DESIGN REVIEW RECOMMENDATION

SDCI # 3035062-LU
901 NW 57TH ST
Seattle, WA 98107

Applicant:
Cone Architecture
2226 3rd Ave, Suite 100
Seattle, WA 98121
Contact: Summer McEneny

ITEMIZED RESPONSE TO EDG
AND MUP CYCLE 1

COMMON AMENITY AREA: RAISED GLAZING FOR PRIVACY, VARIETY OF LANDSCAPE, SITTING OPPORTUNITIES, AND ENCOURAGEMENT OF SOCIAL INTERACTION

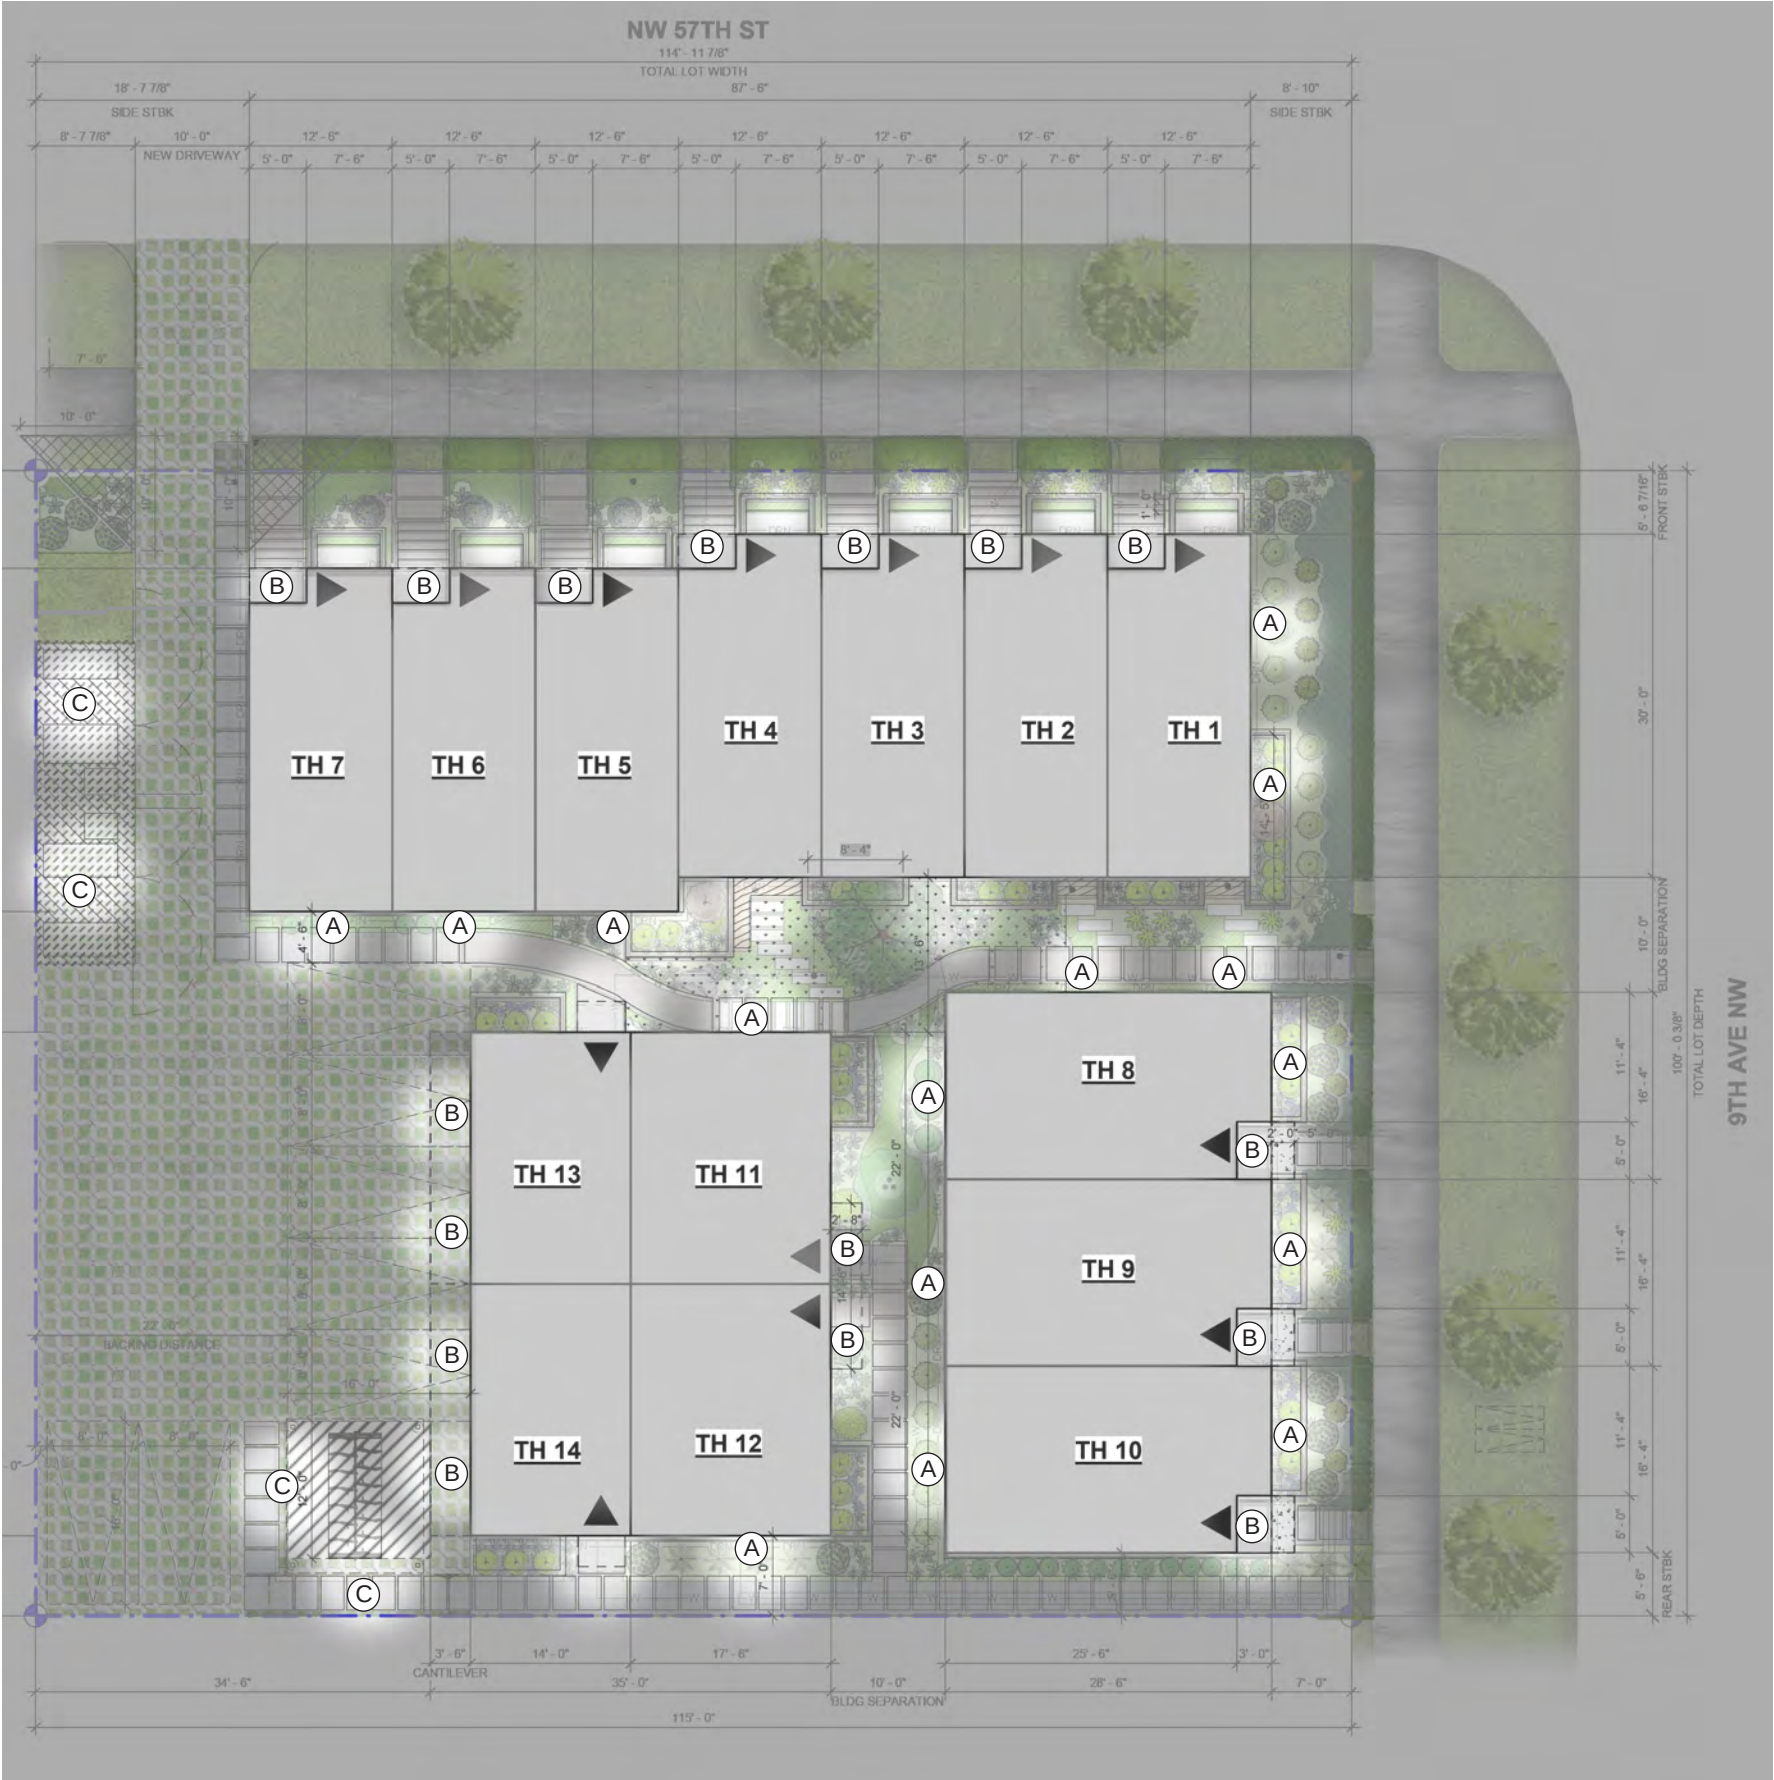
A. Staff is concerned the central, ground level amenity space will not function as activated amenity space as it is dominated by pedestrian circulation. Study how circulation will work in conjunction with the space to not impede upon it. Activate the space by providing seating and opportunities for community interaction while helping define it with thoughtful plantings and hardscape. (DC3-B, DC4-D)

B. Explore opportunities for the east units facing 9th ave NW to have a front yard quality and aesthetic that is in keeping with the neighborhood's precedent of front yards. (CS3-A-3)

APPLICANT RESPONSE:
As illustrated in the EDG packet, the creation of a through-block connection between 9th and 57th is a key goal of the preferred option, in order to better fit with design guidelines and to create transparency into the site from the right of way. While this circulation pattern has been maintained, it has been improved upon by adding a curve to the pathway, opening up more space for landscaping, seating, and other amenity elements. As mentioned above, we avoided adding more circulation to This space by not moving the TH 11 entry to the north side of the unit.

APPLICANT RESPONSE:
The east units facing 9th have a collection of elements at the entry to create a strong front yard quality, including wood, weather protection, a bioretention planter, and large street facing windows connecting the living level at the ground floor to the street beyond. More plantings will be provided in front of the bioretention planter creating a layering effect to help transition from the public to private realm.

**OPTION 3 - PREFERRED
DESIGN STANDARD**
SMC 23.45.518.A.1
FACADE LENGTH

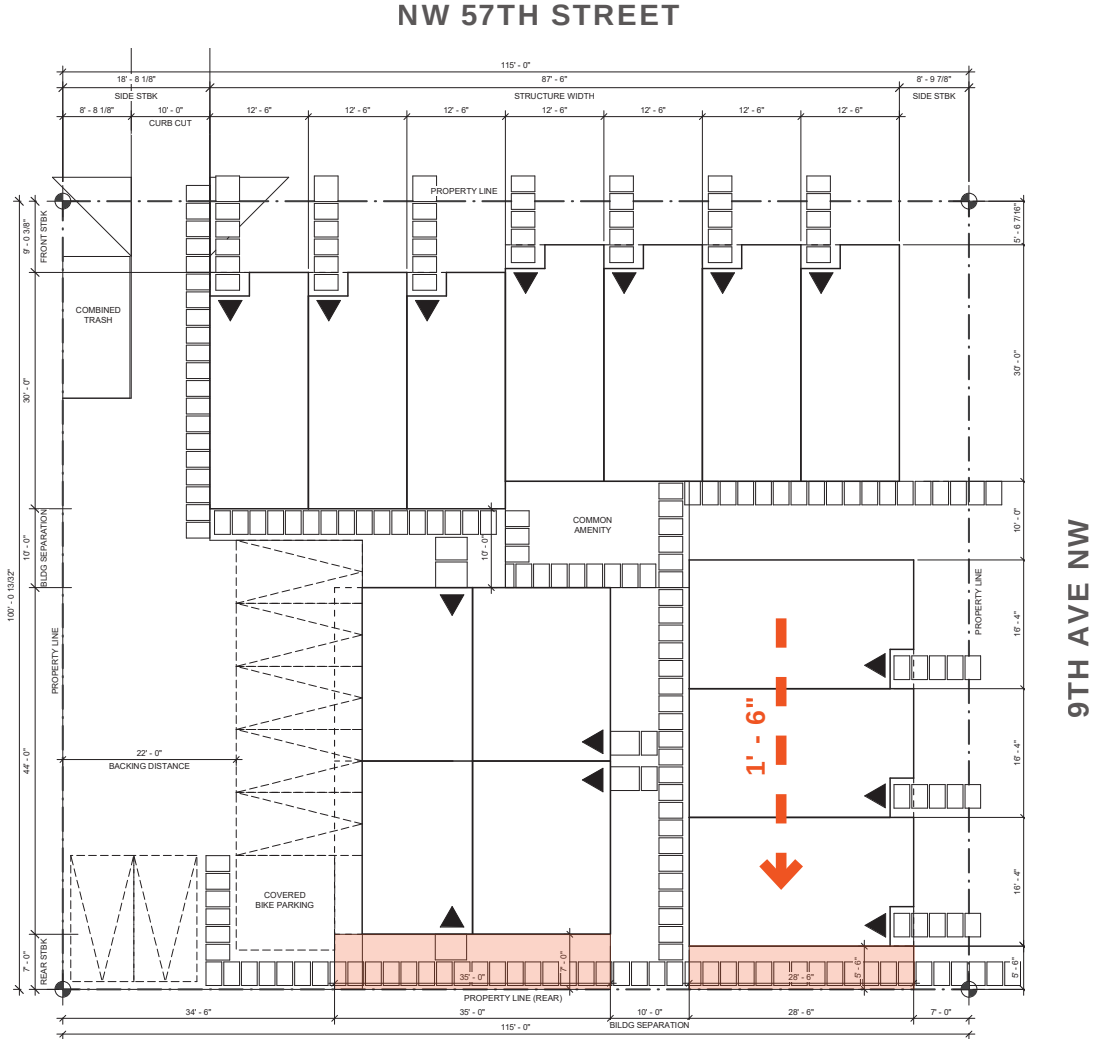
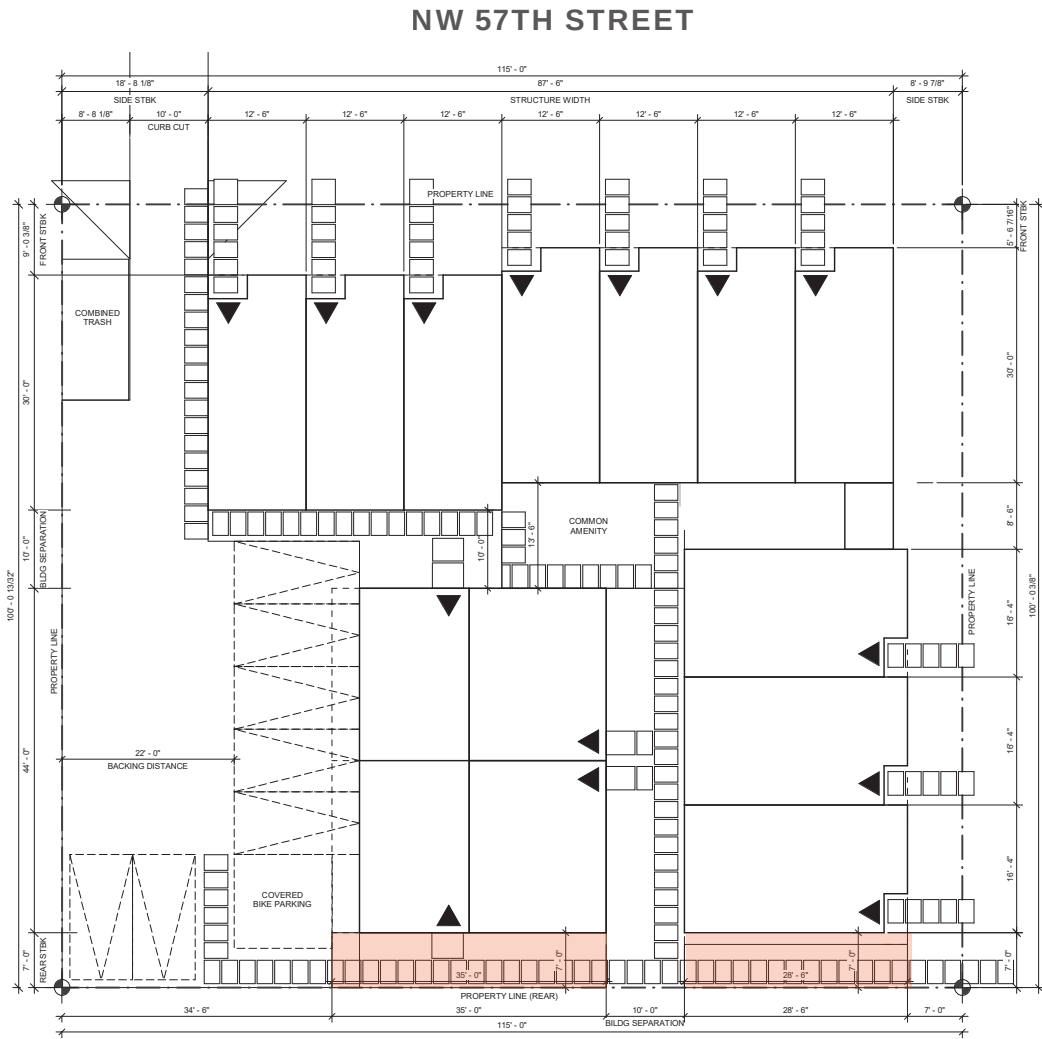
PLANNER'S RESPONSE AT EDG:
Staff supports separate structures along NW 57th St and 9th Ave NW and does not feel a joined building would be in keeping with the residential scale of structures in the neighborhood. Staff preliminarily supports the requested departure. (CS3-A-1)

CODE REQUIREMENT:
The Required rear setbacks for the LR zones for townhouse is 7'-0" avg / 5'-0" min.

DEPARTURE REQUEST:
To allow for a reduction to the required average rear setback of 6.6%.
Allowed: 7'-0" avg / 5'-0" min. Proposed: 6'- 6" avg / 5'-6" min.

RATIONALE FOR DEPARTURE:
The diagram to the left illustrates the code complaint arrangement, by meeting the rear average setback, the building separation is no longer possible at 9th Ave NW. Instead of having two separate buildings facing the streets, the building would join at the corner due to not having the ten feet building separation required. In addition, the pedestrian pathway into the common amenity would be compromised along with the green open space leading into the center of the site. By allowing the average rear set back to be reduced by 6.6% the project gains green open area and thrue building access, while providing more then the required min. set back of 5.5'. Design Guideline: PL1.A.1, PL3.C.2
